**BELL BEND NUCLEAR POWER PLANT
UPDATED FRACTILE CURVES FOR BBNPP
COLA PART 2, (FSAR); SECTION 2.5
BNP-2013-151 Docket No. 52-039**

Reference: BNP-2013-050, R. R. Sgarro (PPL Bell Bend, LLC) to U.S. NRC, "Submittal of Bell Bend COLA Revision 4" dated April 12, 2013

FSAR 2.5 Tables and Figures Mark-up

Figure 2.5-37—{Mean and Fractile Rock Hazard Curves for PGA}

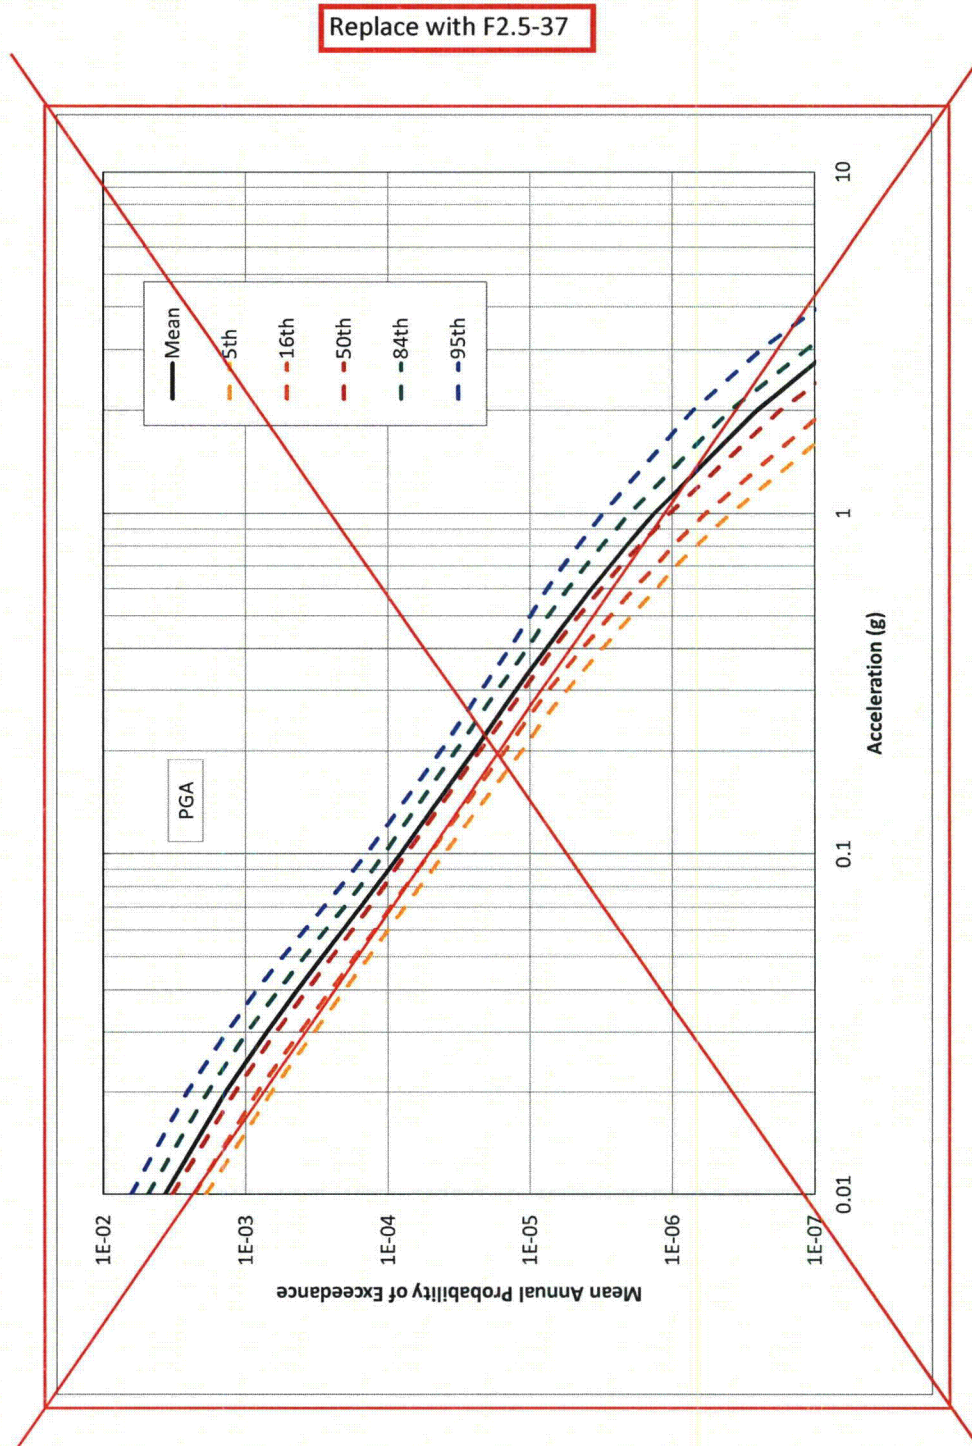
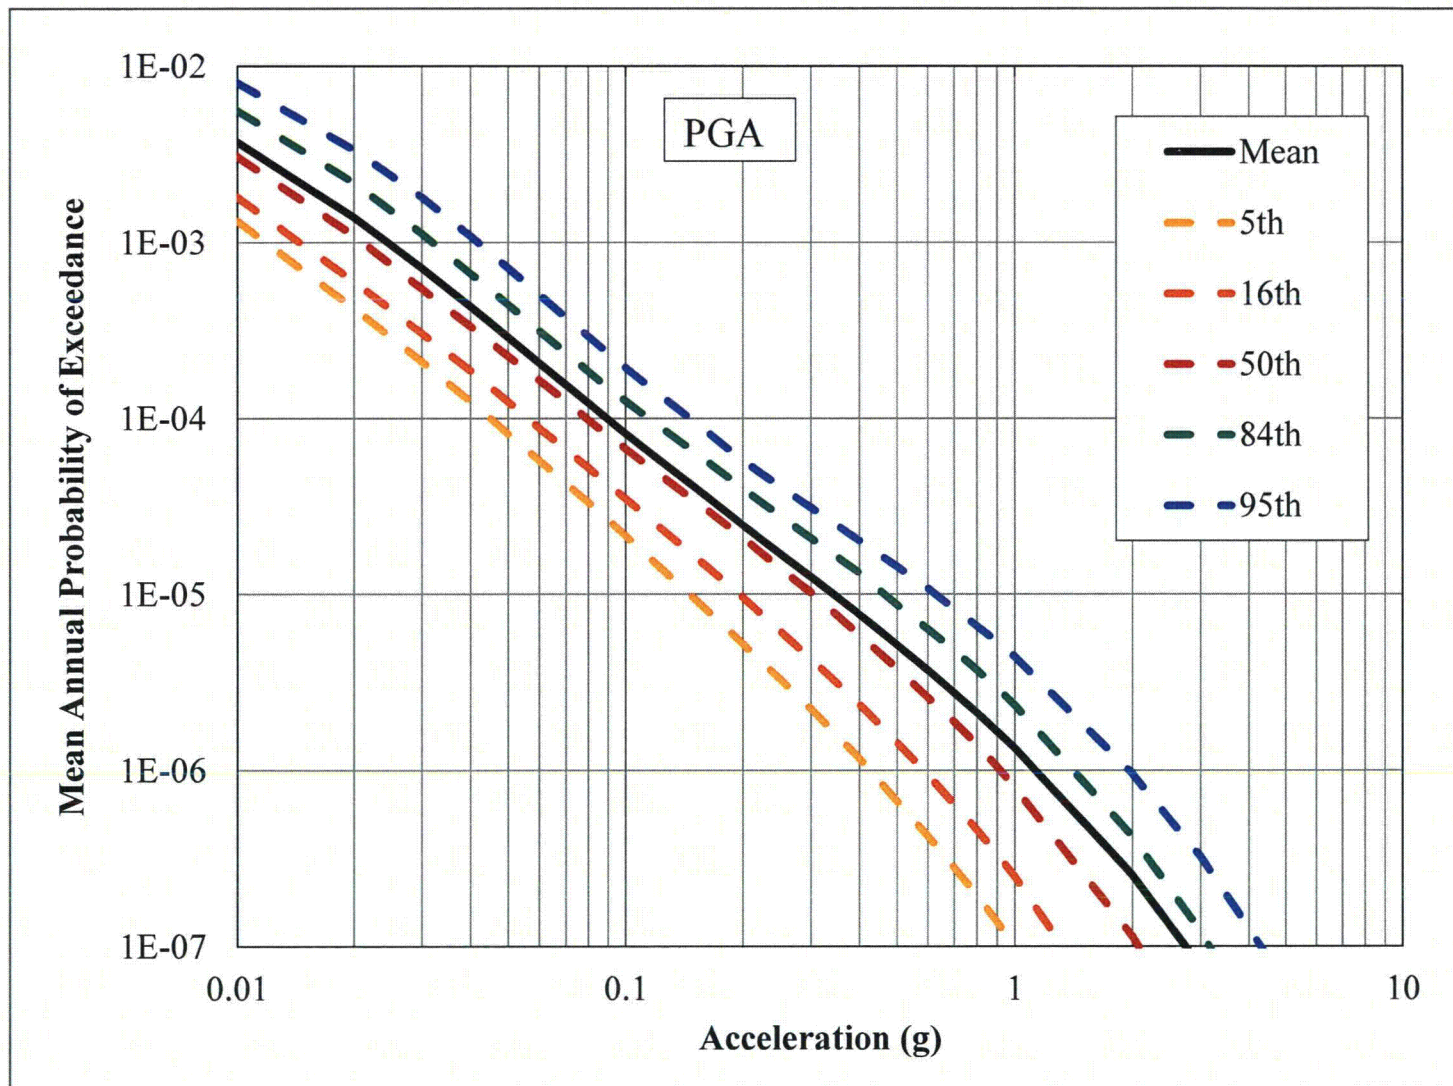
In the referenced correspondence, PPL Bell Bend, LLC (PPL) submitted to the U.S. Nuclear Regulatory Commission (NRC), Revision 4 to the Combined License Application (COLA) for the Bell Bend Nuclear Power Plant (BBNPP). Subsequent to the submittal, an error was found in code used to calculate some of the Fractile Curves used in COLA Part 2 Final Safety Analysis Report (FSAR) Section 2.5. The purpose of this letter is to provide updated tables and figures based on the corrected Fractile Curves. The Enclosure provides marked-up tables and figures indicating which tables and figures are to be replaced.

F2.5-37
